**DOVER LOCAL PLAN EXAMINATION**

**KENT DOWNS AONB UNIT**

**MATTER 3**

## Matter 3 – Housing Allocations

Figure 3 – Contour map

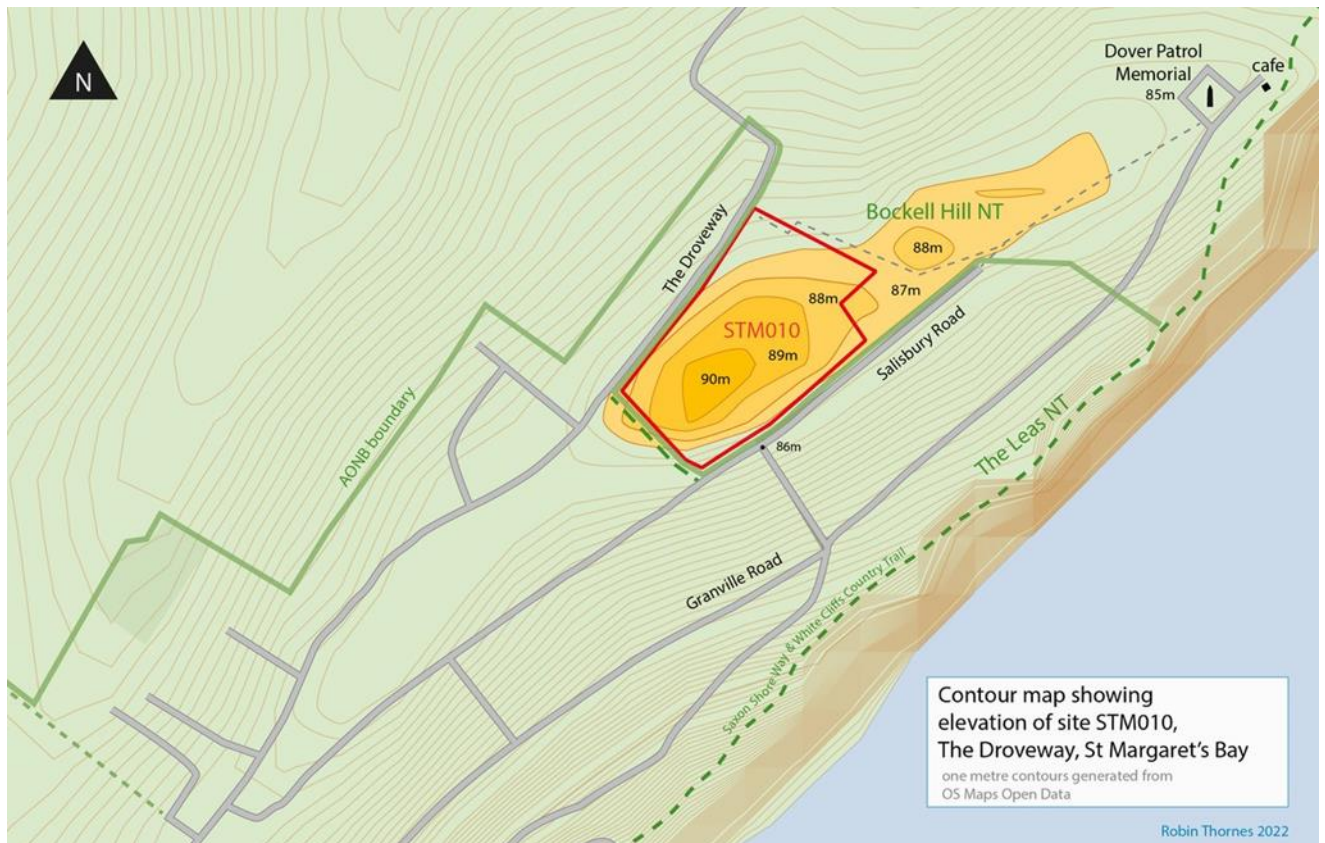
- The topographical map included at Fig 4 is not of a sufficient detail/scale to be helpful, only providing topographical bands of 5 metres which does not allow for useful comparison of the site compared to surrounding land. OS mapping contours show that there is in fact a 5 metre difference between the centre of the site and the housing development on both The Droveaway and Salisbury Road which is a significant difference but this isn't apparent on the topographic map provided at Figure 4 because of the scale used.

- The key on the topographical map appears to be incorrect as it does not align with contour heights provided on OS mapping which indicate much of the site sitting between the 85 and 90m contour lines, while the key provided in Figure 4 indicates the height of the site to be in the region of 49m.

The AONB Unit considers the contour line map below in Figure 3 below (taken from the Regulation 19 Submission of The St Margaret's at Cliffe Residents Group) is much more helpful in illustrating the height of the site relative to surrounding land and existing development. It shows that the site is higher than all surrounding land, not just the housing to the southwest as advised in the LVS. This demonstrates that existing built form in Salisbury Road is built at the 84 to 85m contour line while that in The Drove opposite the site is at 86m at its highest at the southwestern end, reducing to 83 metres at the northern end opposite the site. In contrast, the majority of the proposed allocation is in the 87m to 90 metre contour range (as can be seen in Fig 1 below there are small areas of lower pockets of land in the south western and northern corners of the site) and allowing for a driveway set back, any built development would be likely to be built at a minimum of 88 metres and as a result much more prominent in the landscape than existing built form in a part of the Kent Downs AONB that is recognised as having particular visual sensitivities.
